Device	XC822/824MT Series
Marking/Step	AA
Package	PG-TSSOP-16/DSO-20

This Errata Sheet describes the deviations from the current user documentation. The module oriented classification and numbering system uses an ascending sequence over several derivatives, including already solved deviations. So gaps inside this enumeration can occur.

**Figure 1 Counting sequence of T12 in center-aligned mode**

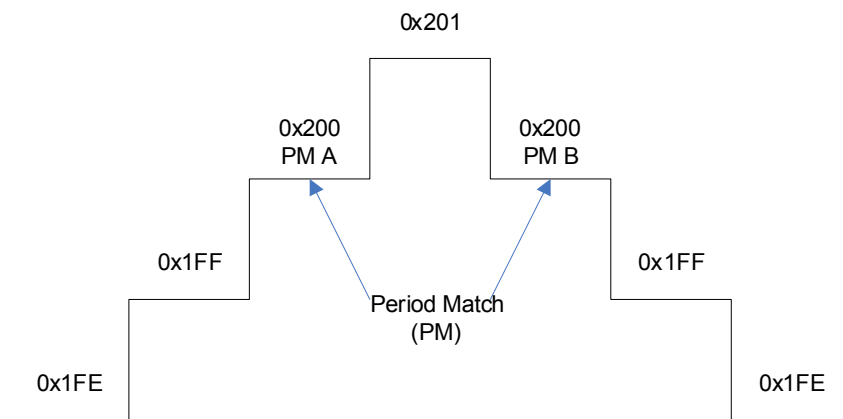
## **CCU6\_XC8.H002 CCU6 PM event in center-aligned mode**

After detecting a period match (PM A) in centre-aligned mode, T12 counts down from PM + 1 as shown below:

This means a second PM event (PM B) will occur during the counting down. If ADC is triggered externally via REQTRxC (T12PM), it will be triggered twice in succession. Depending on how real-time the application code is running as well as the T12 count rate and ADC conversion rate, the application could observe two ADC interrupts - once at PM A and once at PM B.

To avoid triggering twice the ADC interrupts, it is suggested to use REQTRxF from multi-channel mode instead of REQTRxC as the trigger source for ADC. Additional initialization are as follows:

- Configure MCMCTR.SWSEL = 101<sub>B</sub> (Transfer on T12 period match)
- Configure MCMCTR.SWSYN = 00<sub>B</sub> (Direct transfer)
- Write to MCMOUTSTL = CF<sub>H</sub> (To enable multi-Channel PWM pattern on CC6x and COUT6x)
